CROSSROADS MIXED USE FILING NO. 2

CONSTRUCTION PLANS

TITLE SHEET

V4_CDs Comments.pdf Markup Summary

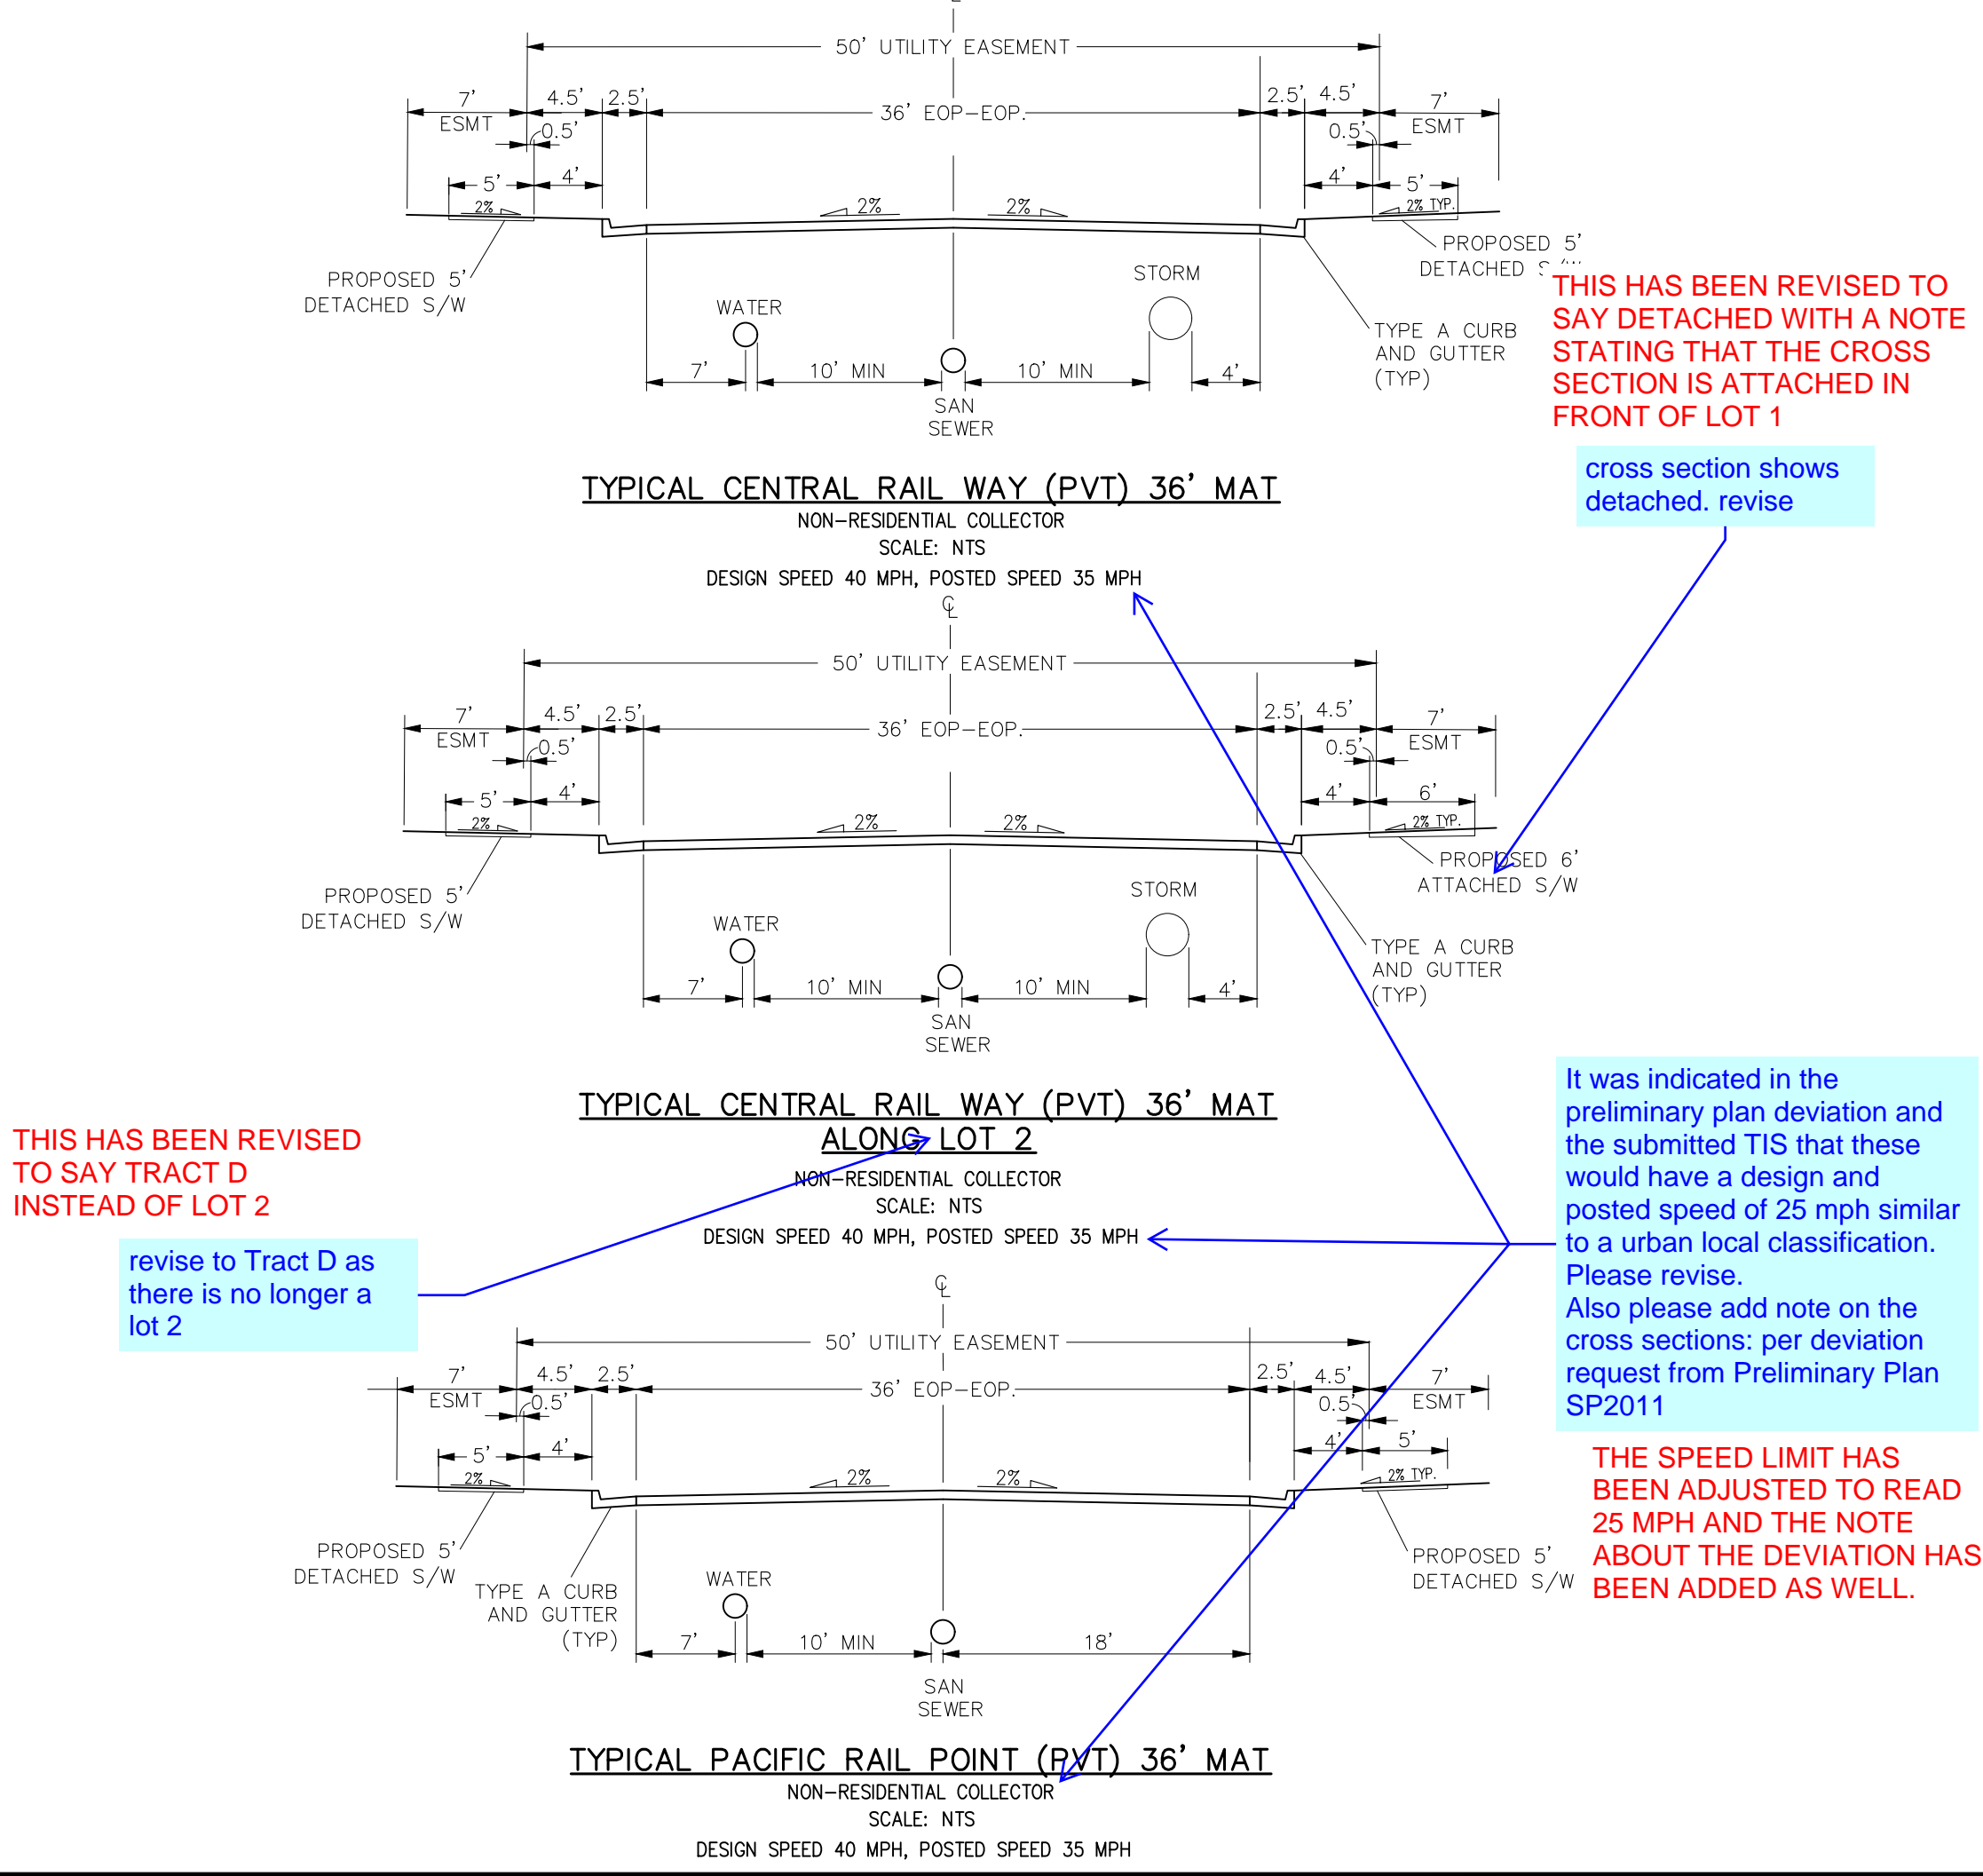
It was indicated in the preliminary plan deviation and the submitted TIS that these would have a design and posted speed of 25 mph similar to a urban local classification. Please revise.
Also please add note on the cross sections: per deviation request from Preliminary Plan SP2011

revise to Tract D as there is no longer a lot 2

cross section shows detached. revise

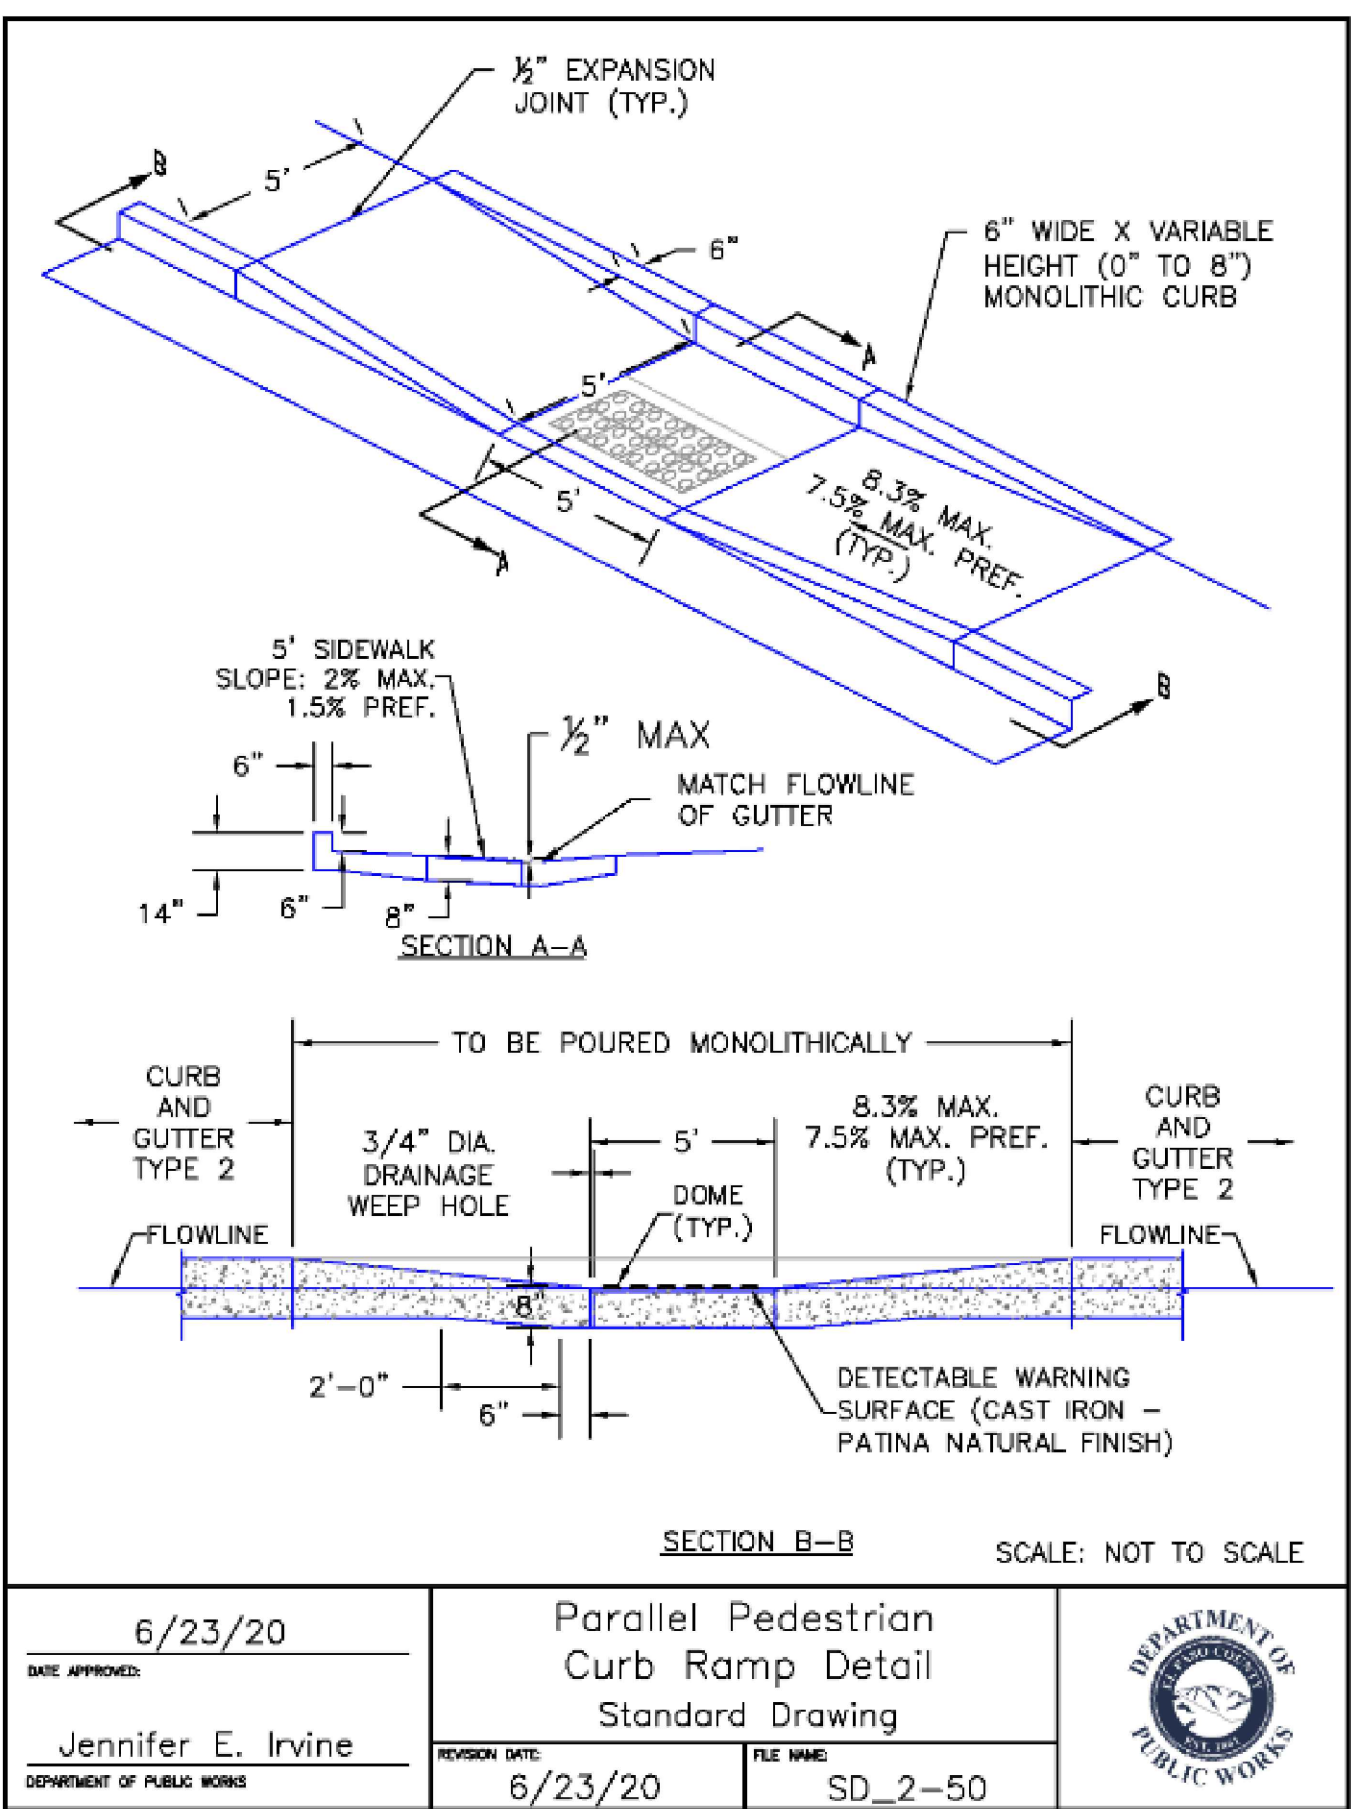
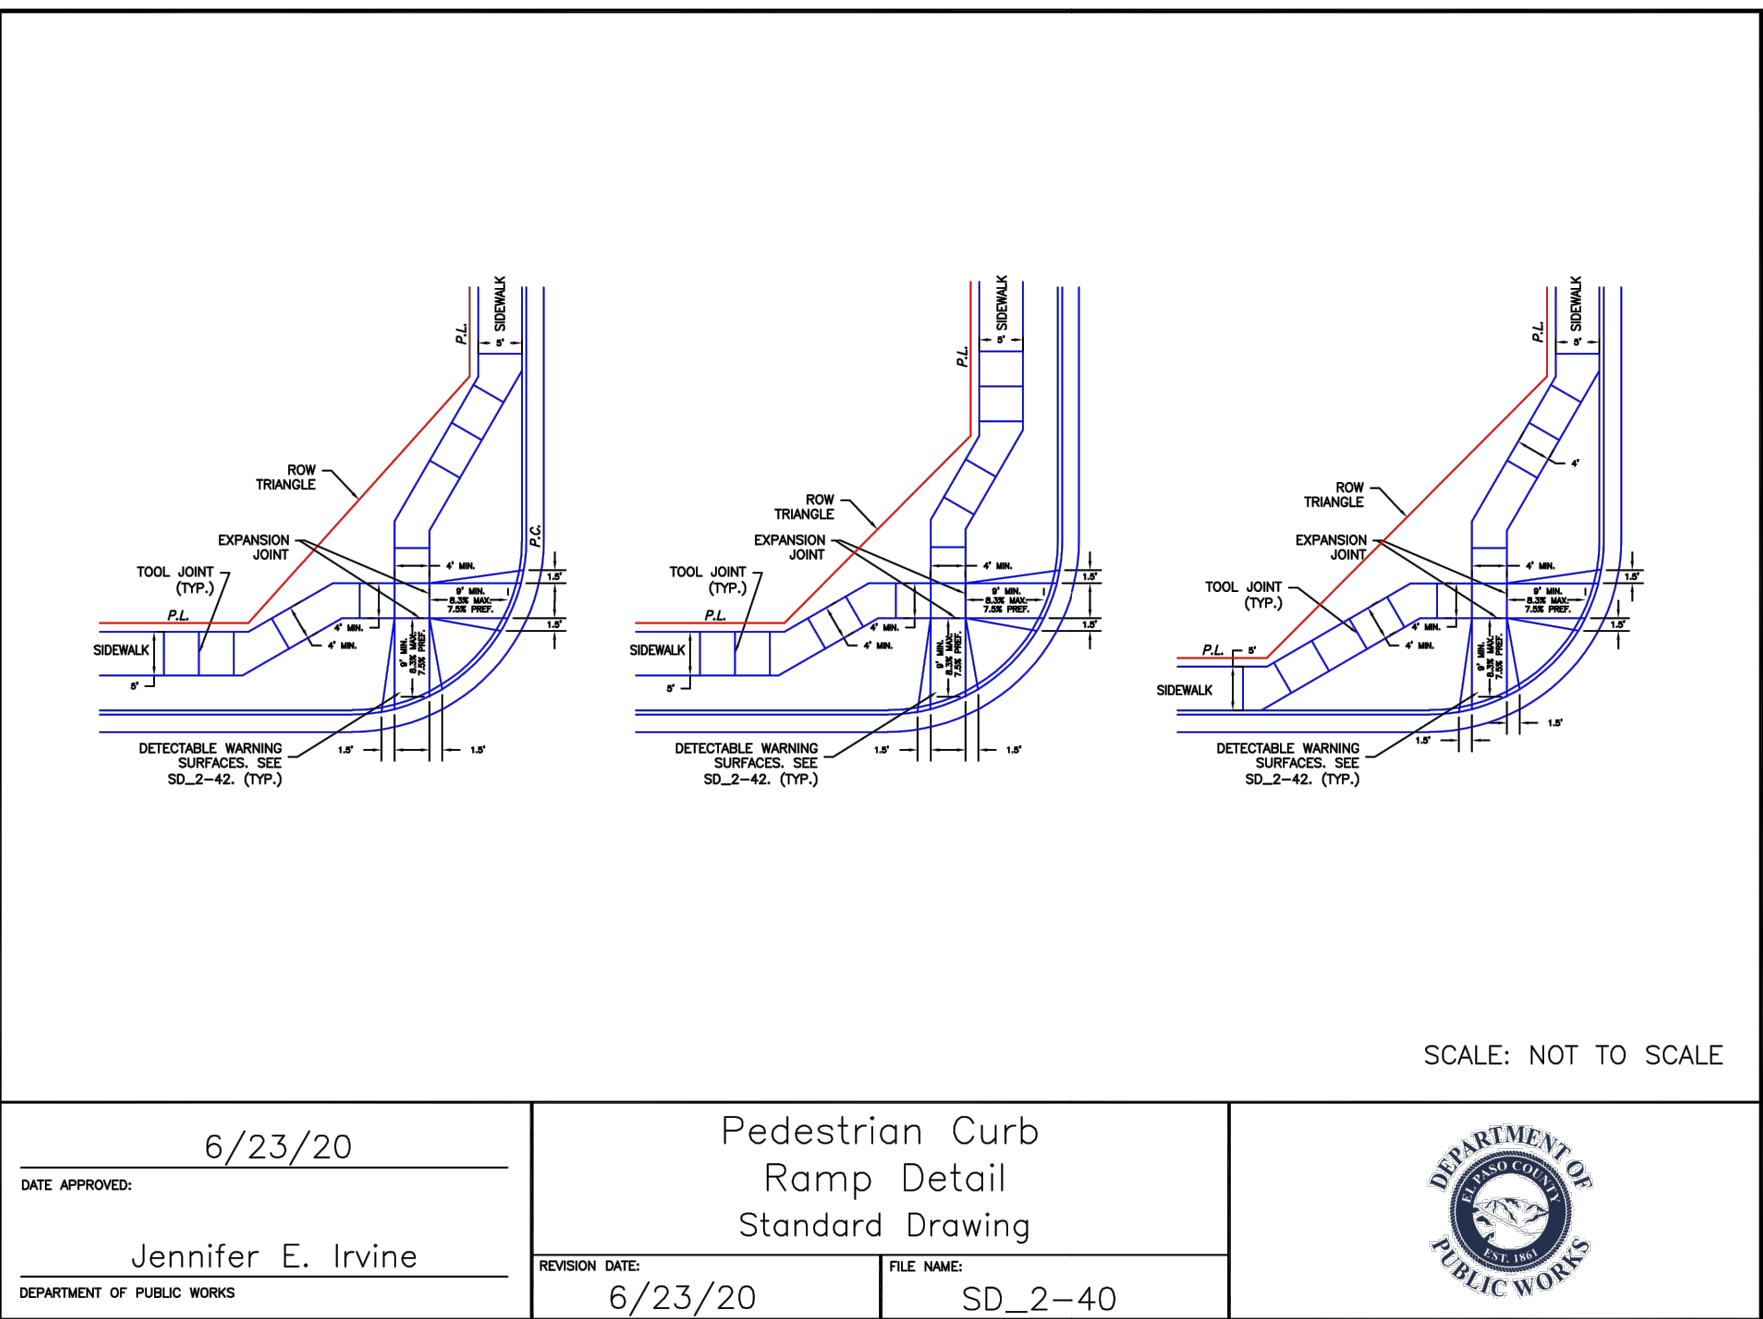
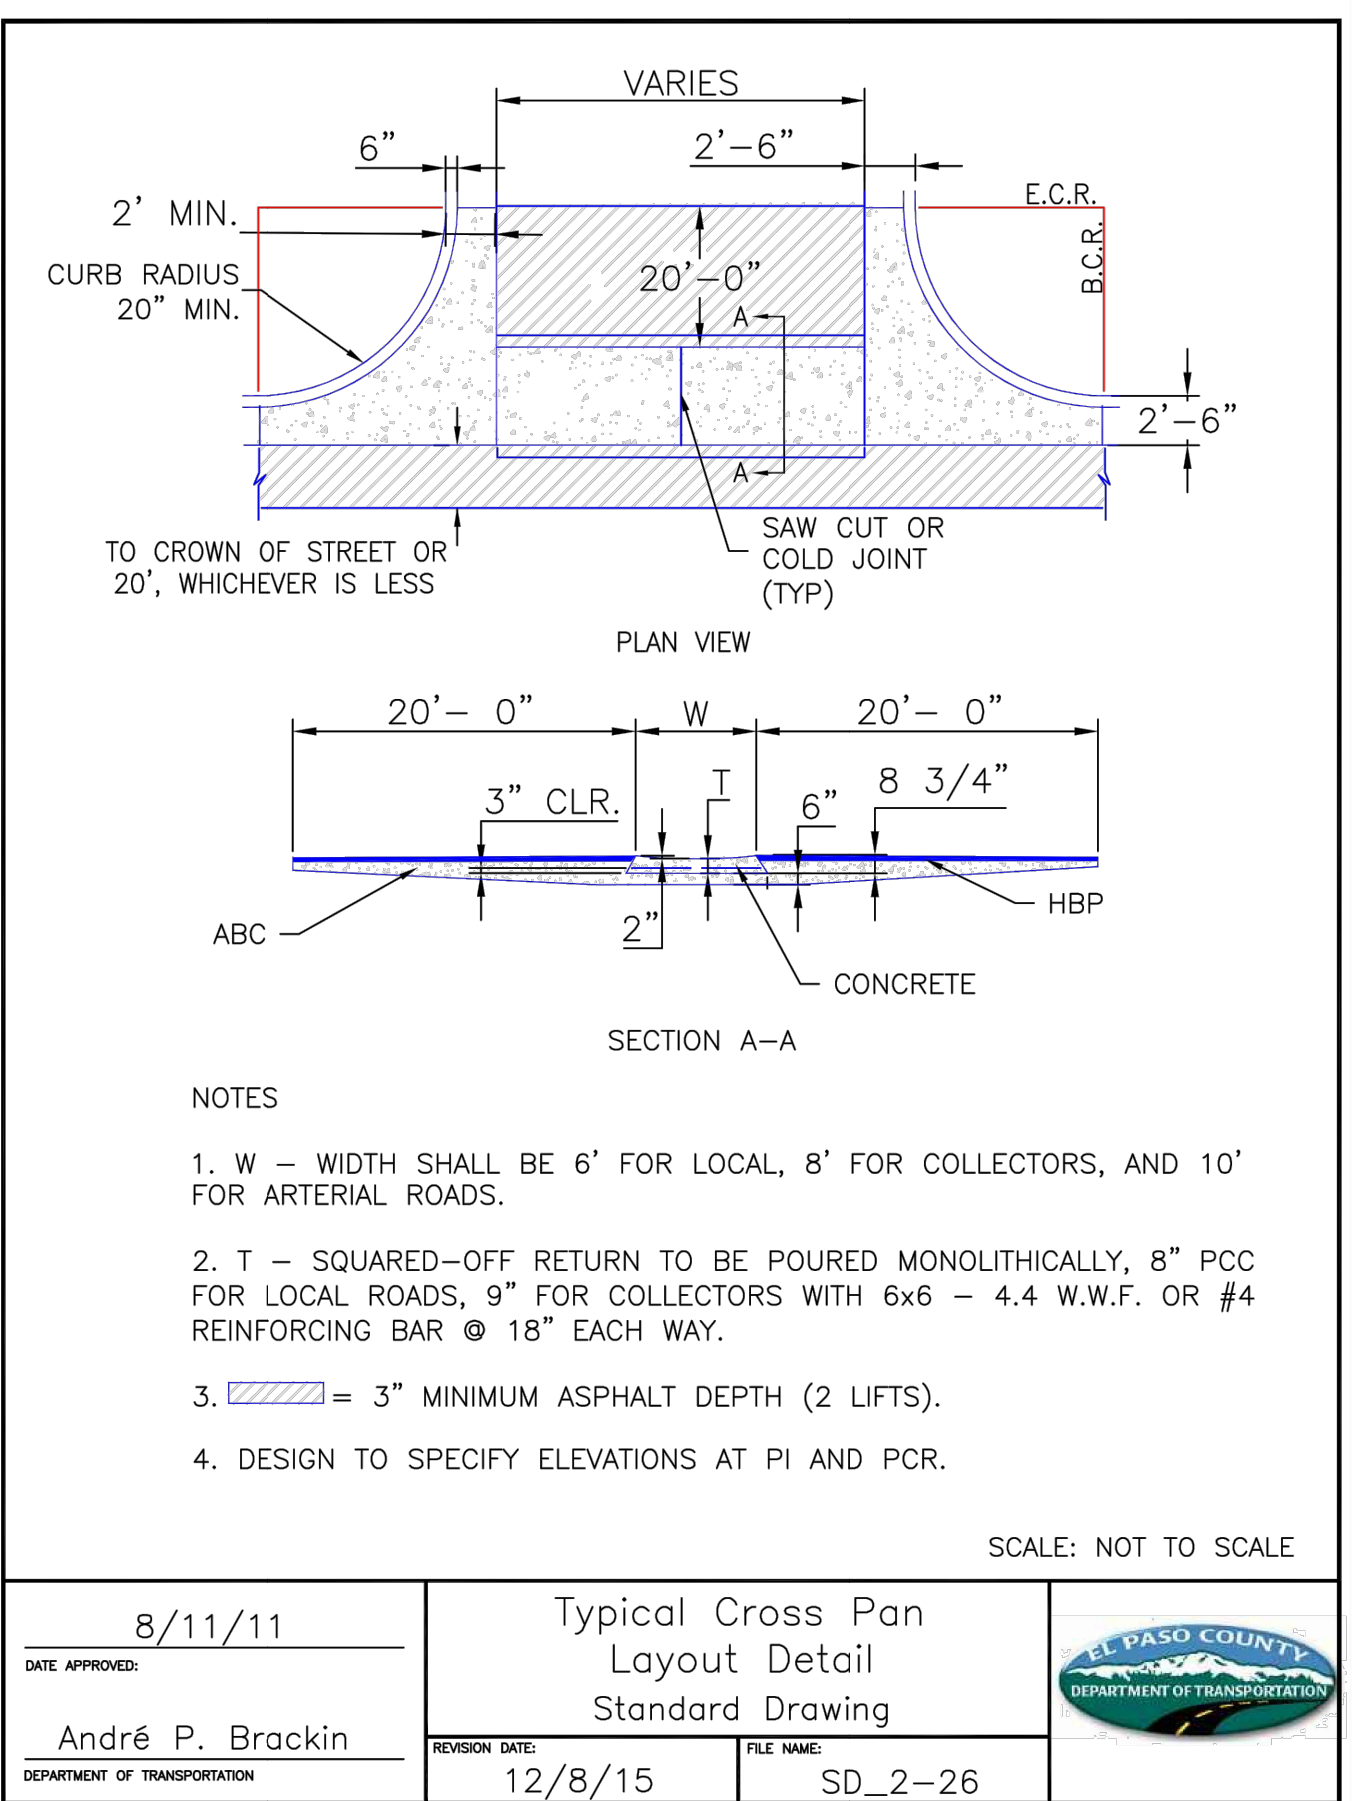
Provide receiving pedestrian ramp across the street.

Label. Provide information.

Provide matchlines on all drawings.

Should be detached sidewalk

Add arrows to legend

Show entire property line and sidewalk

Show and label running slope and cross slope on sidewalks.

Please revise the drawings and texts so that there is no conflict. Will there be curbs cuts and a driveway for or will the sidewalk continue through?

Please extend to show the entire sidewalk along Southern Rail Pt and how it ties to the sidewalk along Meadowbrook.

The cross sections show a detached sidewalk. Revise to match. Is there a reason for having an attached sidewalk at this location? Please give us a call to discuss.

cross section show a detached sidewalk. revise to match.

Refer to ECM 2.5.2.C.3
